Addendum #1 - Issued on September 12, 2011

Regarding Bids for The Source Roof Replacement (**ITB 11-017C**) for the Lucas County Commissioners, bid opening originally scheduled for September 15, 2011.

ADDENDUM NO. 1

The Source Roof Replacement

SKRP-1 SCALE: 1/16" = 1'-0"

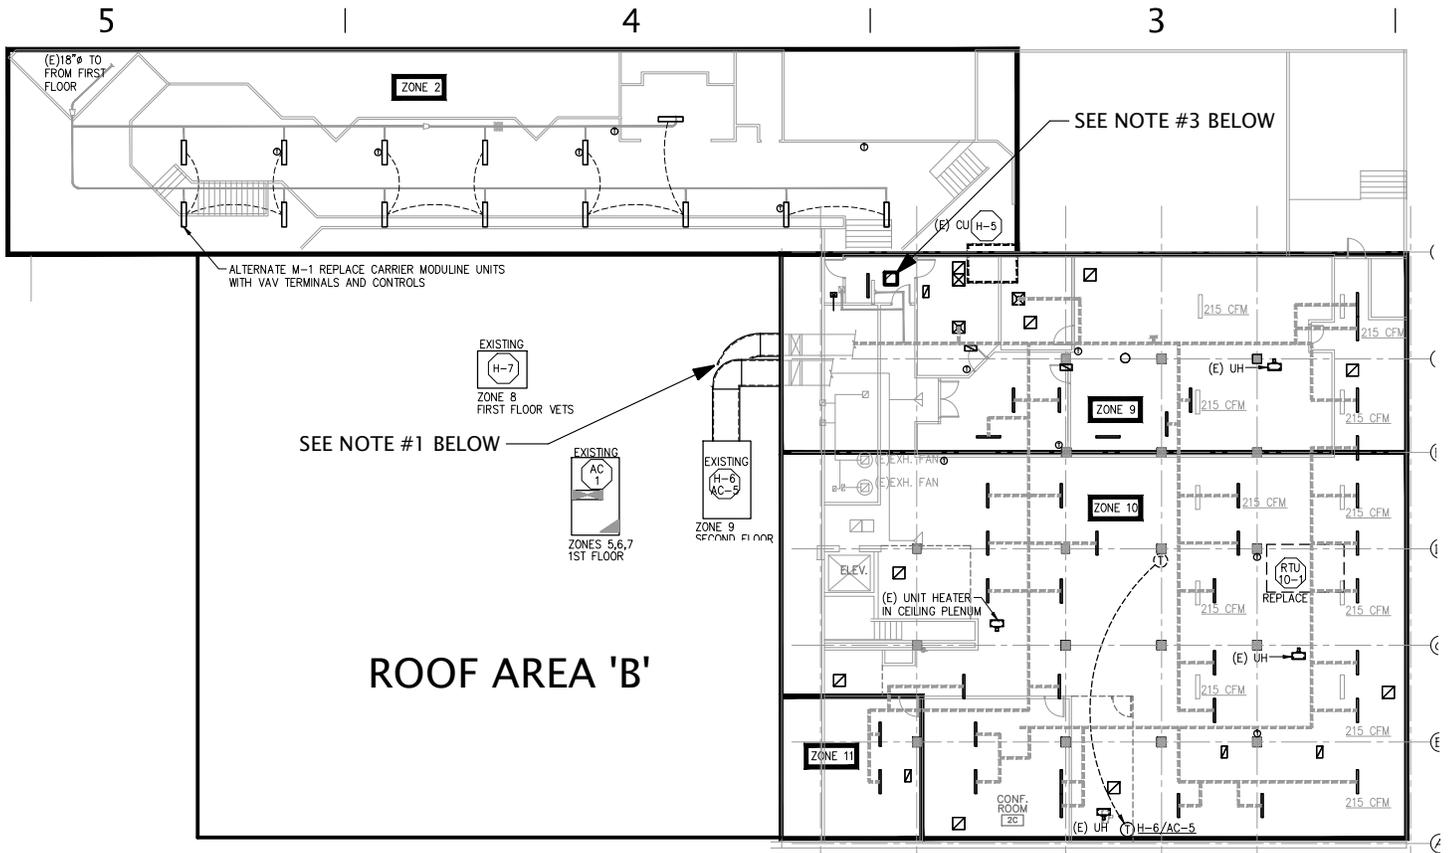
Item #1 – Added work scope for removal of exposed insulated sheet metal ductwork and replace with insulated flexible ductwork from existing roof top unit to existing wall penetration at Roof Area ‘B’. This work is the responsibility of the roofing contractor and shall be performed by an experienced mechanical contractor.

1. Roofing contractor shall secure services of a mechanical contractor to remove existing exterior exposed supply and return air ductwork and related insulation, supports, and connections from unit to ductwork penetration point of existing exterior wall. Provide temporary insulated (min. R-8) flexible supply and return air ducts and provide transition fittings for attachment to existing roof top unit and existing ductwork at exterior wall penetration. Flexible ductwork shall be sized to provide at the same equivalent free area as the existing metal ductwork. Provide sealants and necessary flashing at wall penetration to make transition weather-tight. Roofing contractor is responsible to maintain the temporary flexible ductwork in operational and weather-tight condition during and after completion of roof replacement work. Final release of responsibility will be assigned at project close-out.

2. Removal of temporary flexible supply and return air ductwork and replacement with permanent sheet metal supply and return ducts and related insulation, supports and attachment will be provided under a separate contract and will not be the responsibility of the roofing contractor.

3. Provide roof curb for natural gas piping penetration. Final location shall be coordinated with the Architect.

Product data and sizing information on the flexible supply and return air ductwork shall be provided to the Architect for review and approval prior to placing orders, fabrication or installation.
